Addendum No. 1
Rock River Water Reclamation District
Plant Roadway Improvements 2020
Capital Project No. 2106

This Addendum No. 1, dated August 13, 2020, for the above referenced project, supersedes all contrary and conflicting information in the specifications and contract documents, which are hereby supplemented or revised as follows:

PLANT ROADWAY IMPROVEMENTS 2020 CAPITAL PROJECT #2106

REMOVALS - NORTH SITE

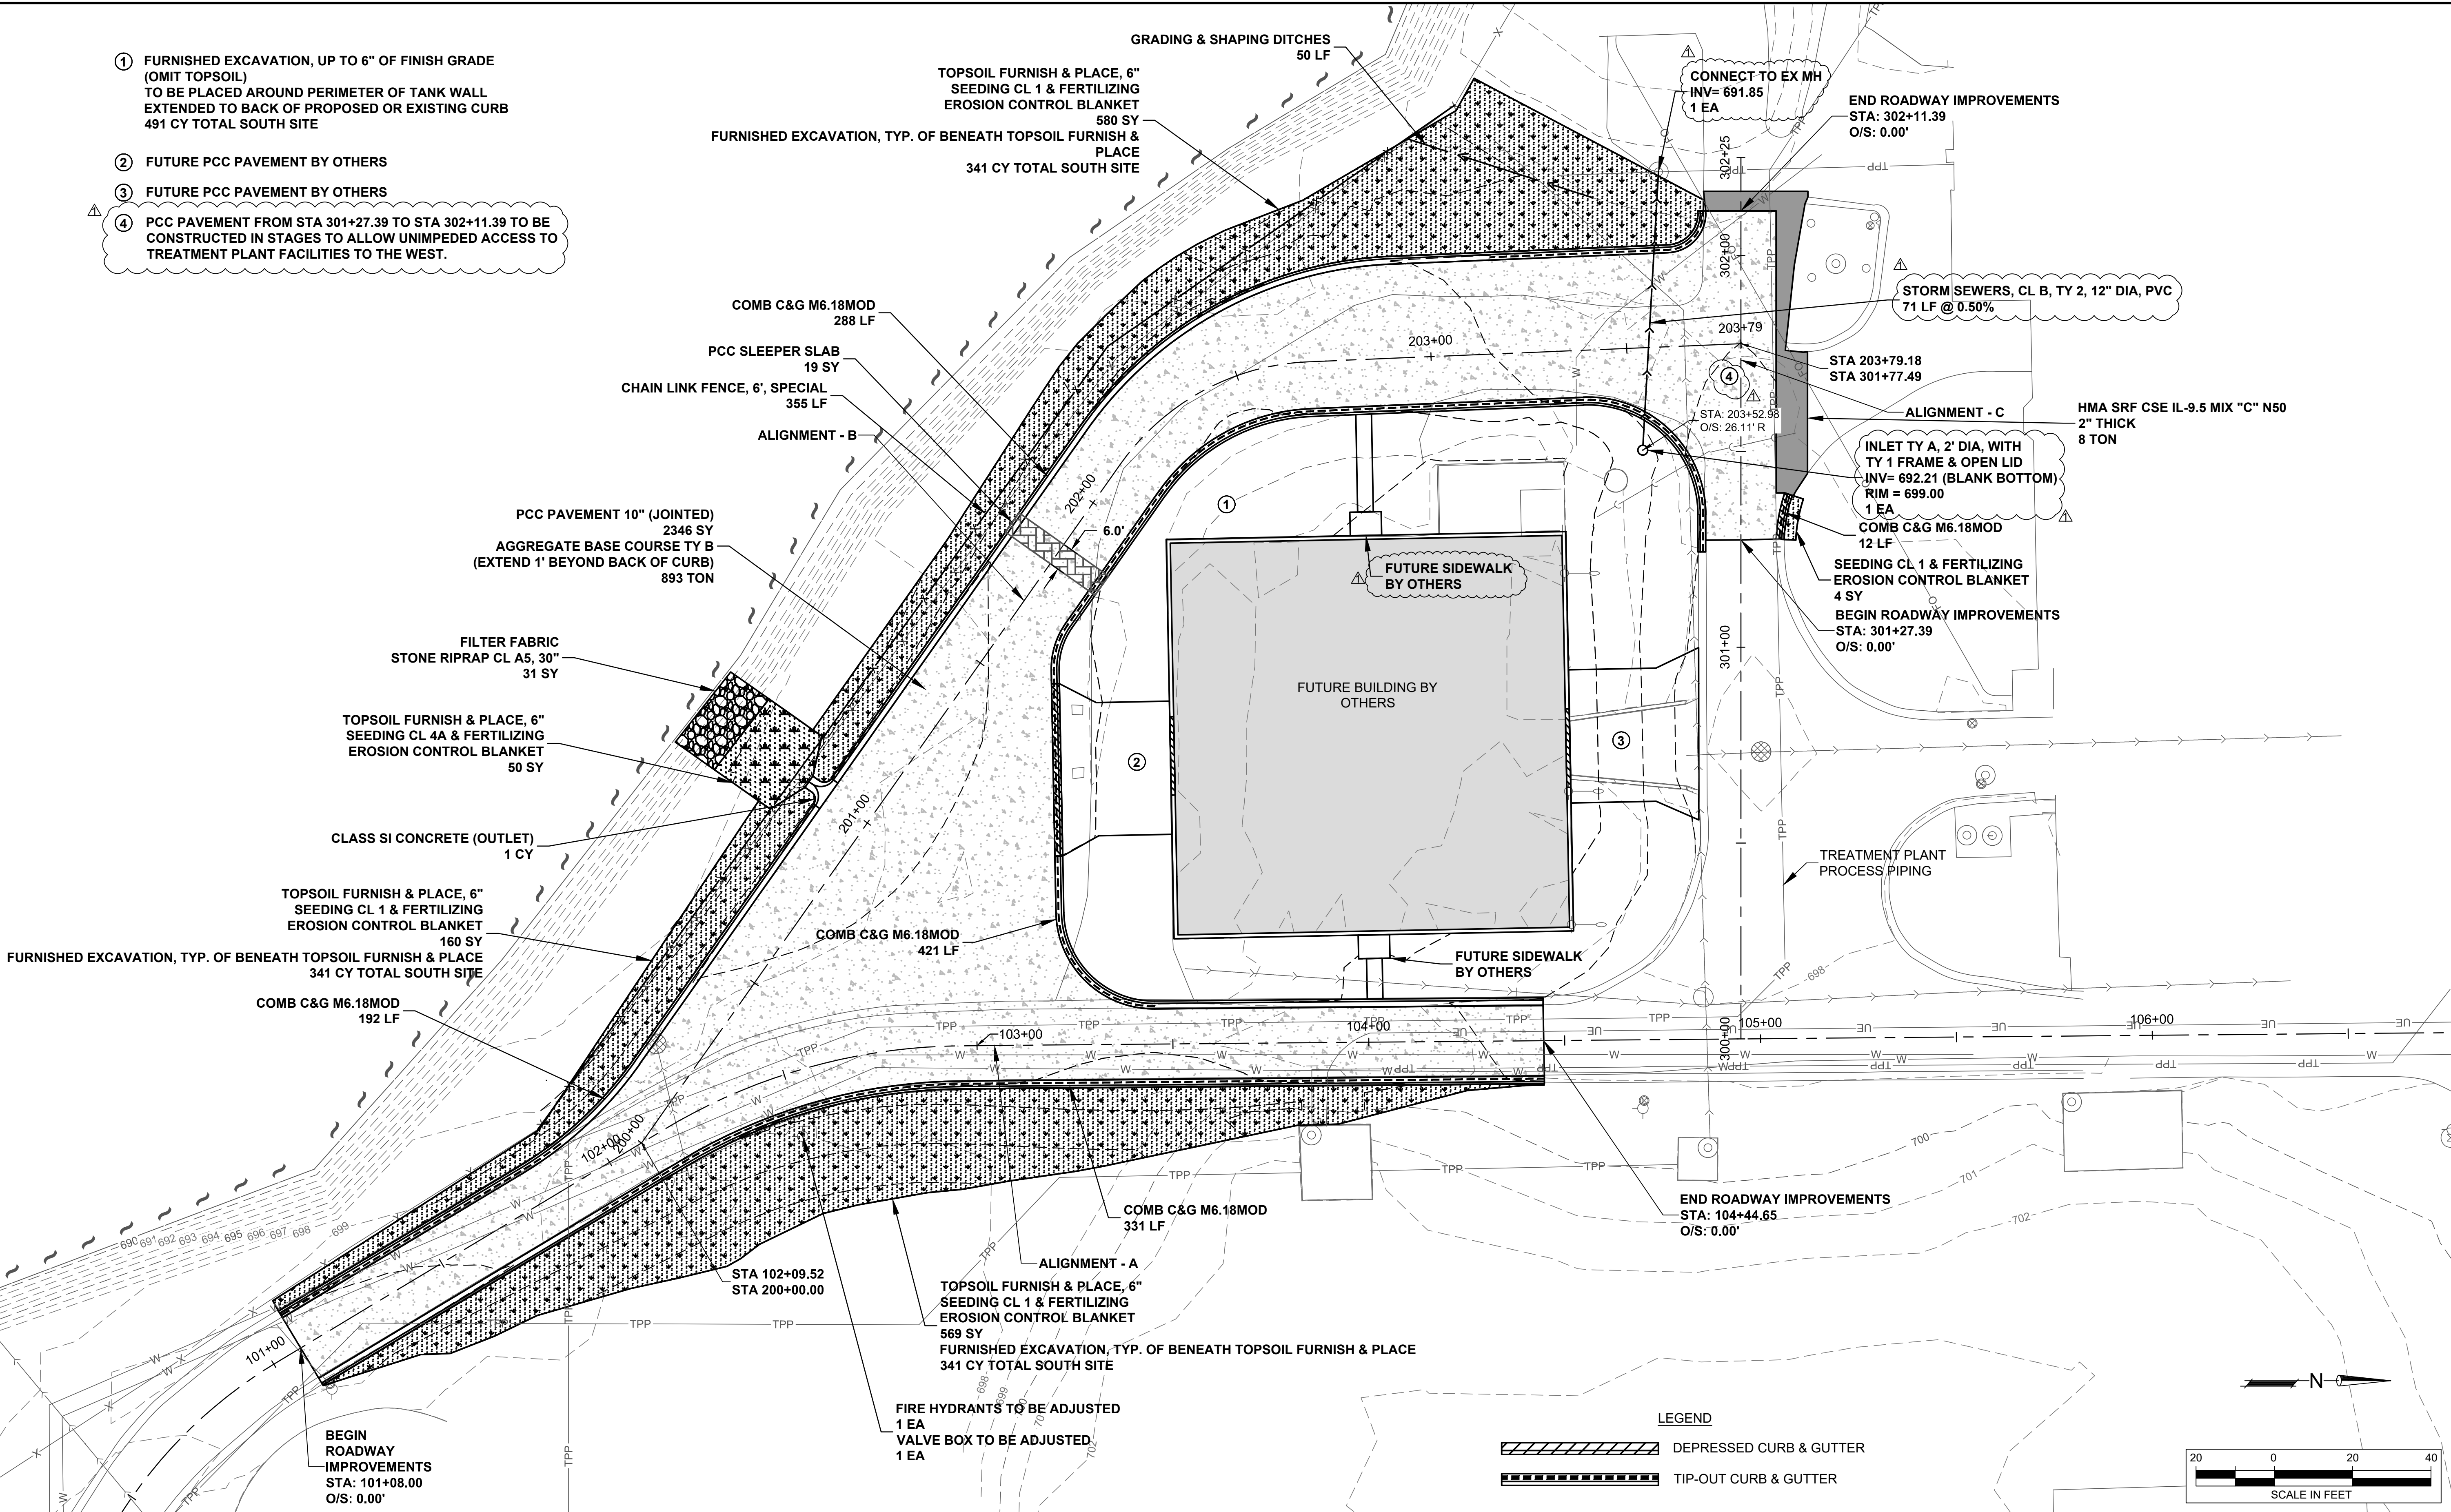
1. Removals plan has been updated to reflect additional PCC pavement to be removed; quantity of PAVEMENT REMOVAL has been updated in accordance with this addition.

SITE PLAN - SOUTH SITE

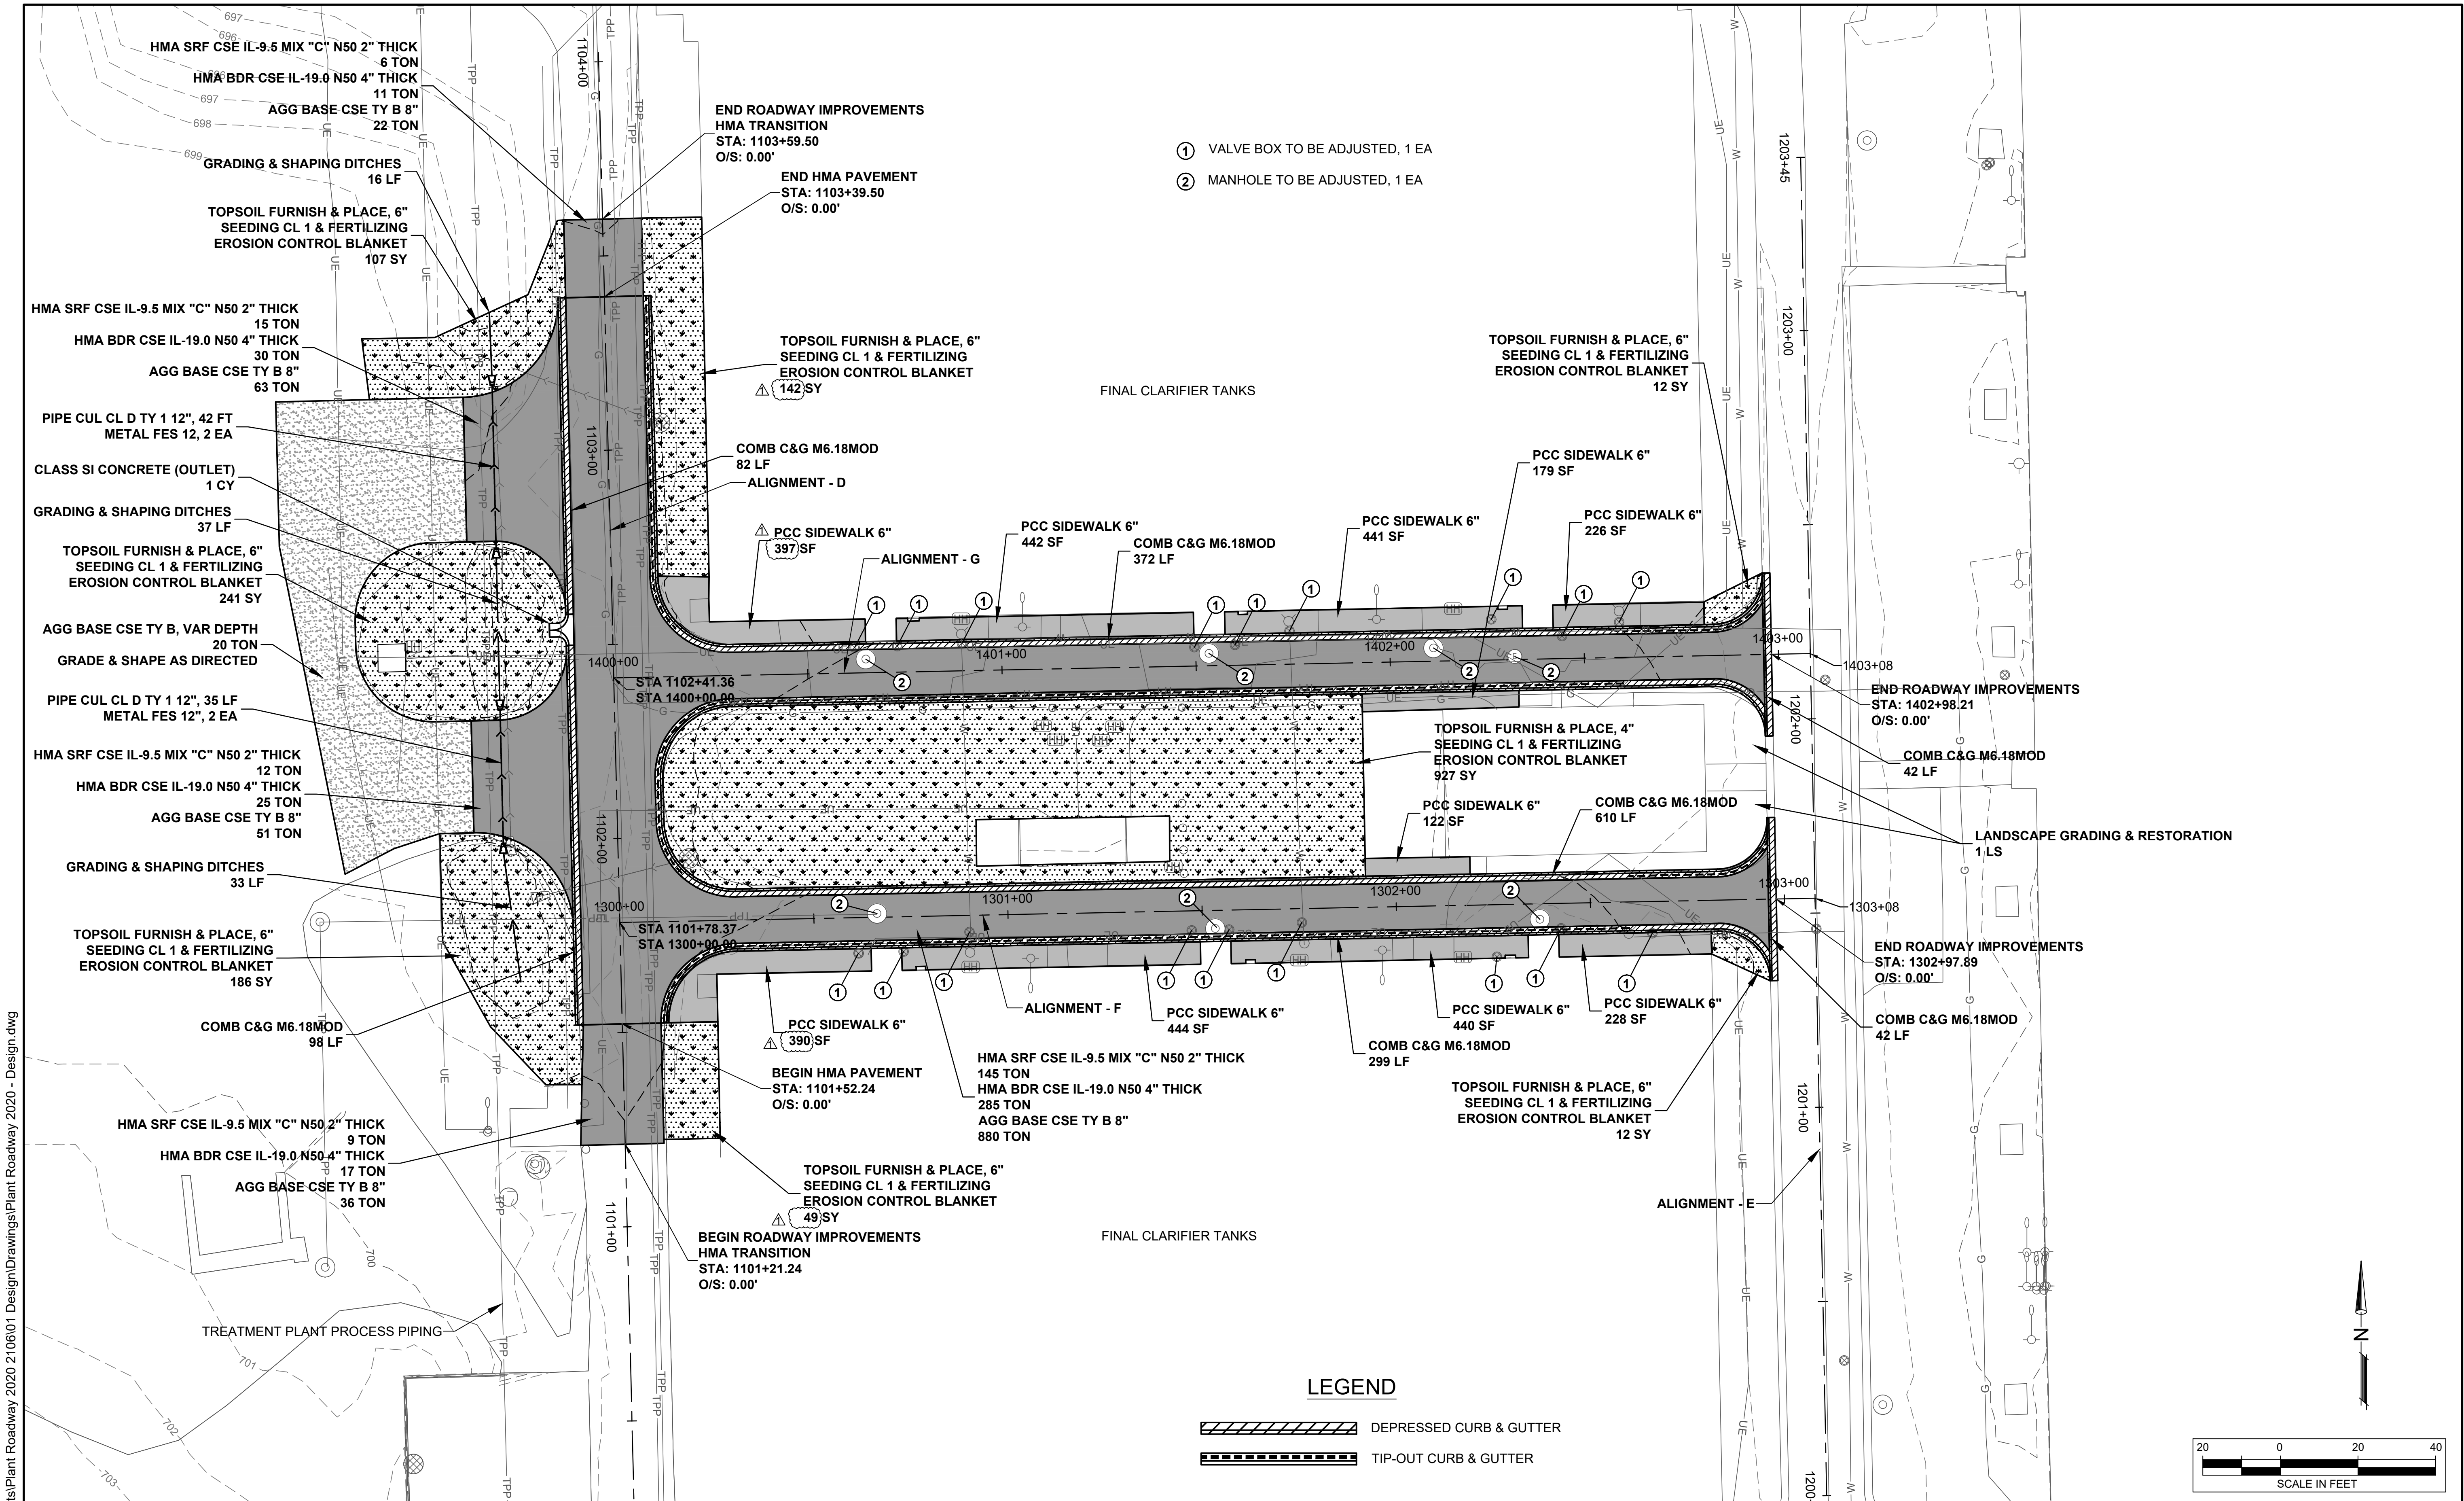
1. Site plan has been updated to reflect the addition of the CONNECT TO EXISTING MANHOLE, STORM SEWERS, CLASS B, TYPE 2, 12" DIA. PVC, and INLETS, TYPE A, 2' DIA. WITH TYPE 1 FRAME AND OPEN LID pay items.
2. Site plan has been updated with Note 4 delineating that PORTLAND CEMENT CONCRETE PAVEMENT, 10" (JOINTED) between STA 301+27.39 and STA 302+11.39 shall be constructed in stages to allow unimpeded access to treatment plant facilities to the west.

SITE PLAN - NORTH SITE

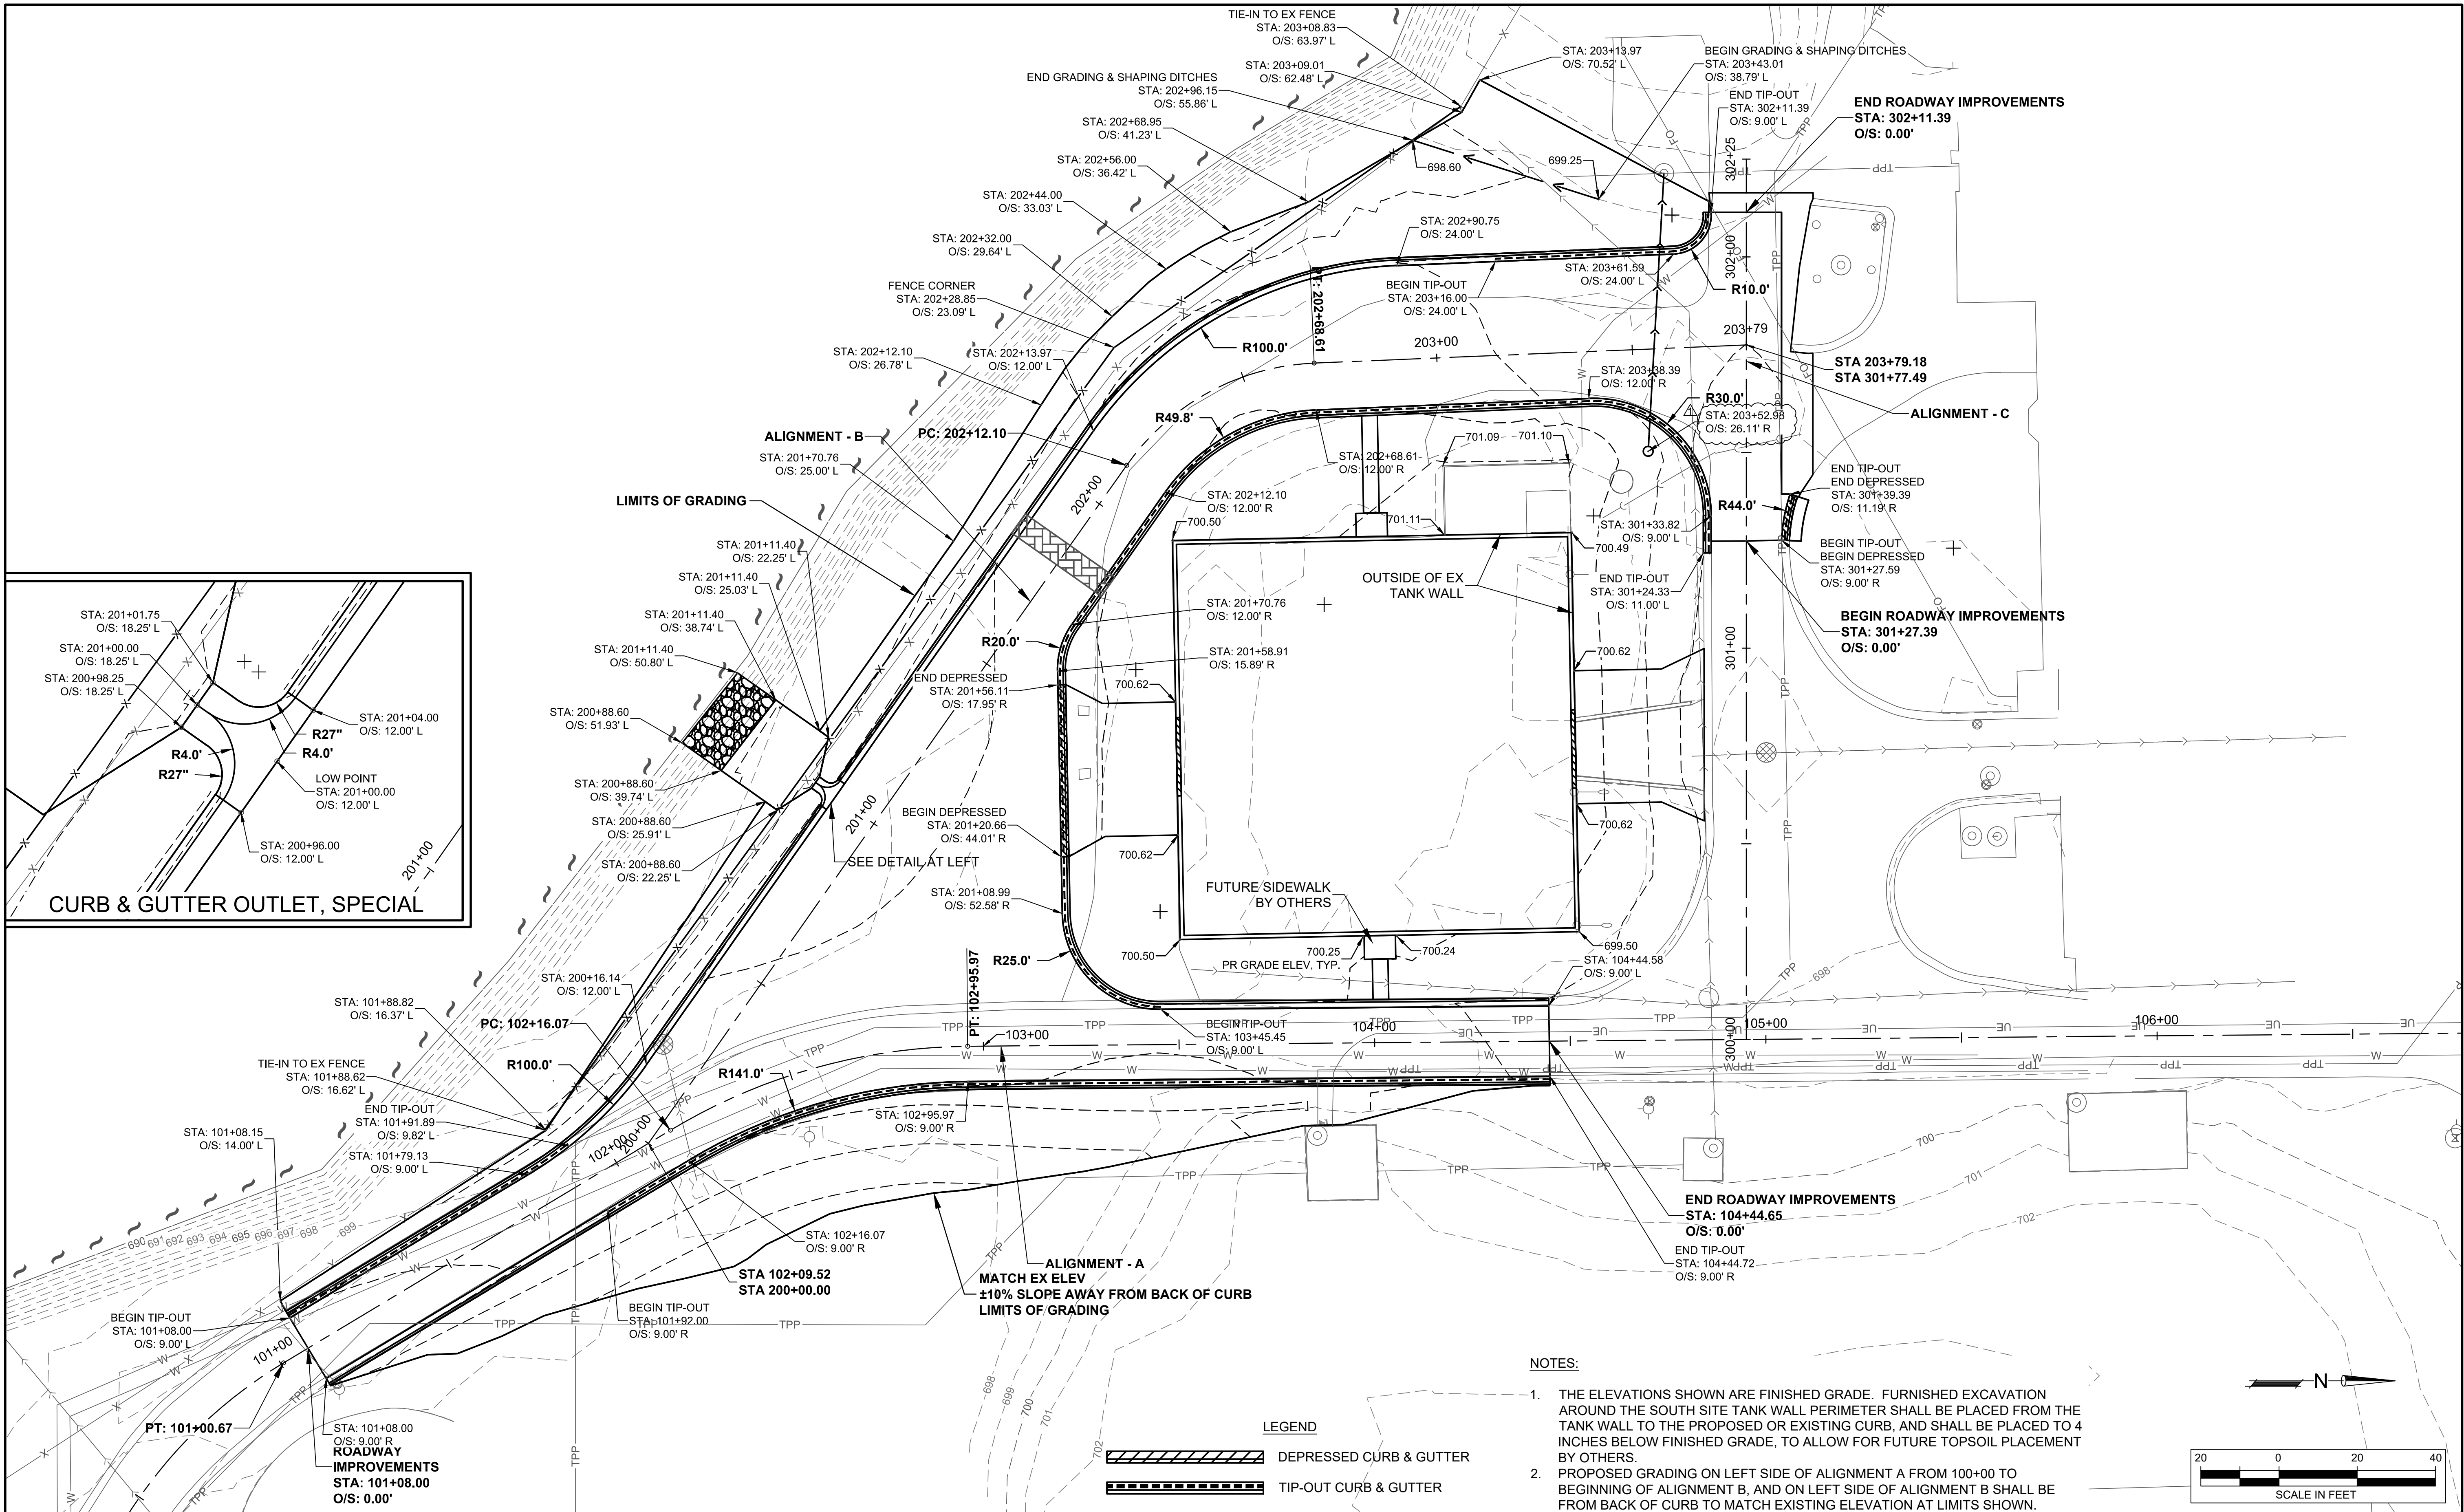
1. Site plan has been updated to reflect additional PORTLAND CEMENT CONCRETE SIDEWALK, 6" and a revision in the quantity of TOPSOIL FURNISH & PLACE, 6", SEEDING CLASS 1 & FERTILIZING, and EROSION CONTROL BLANKET.
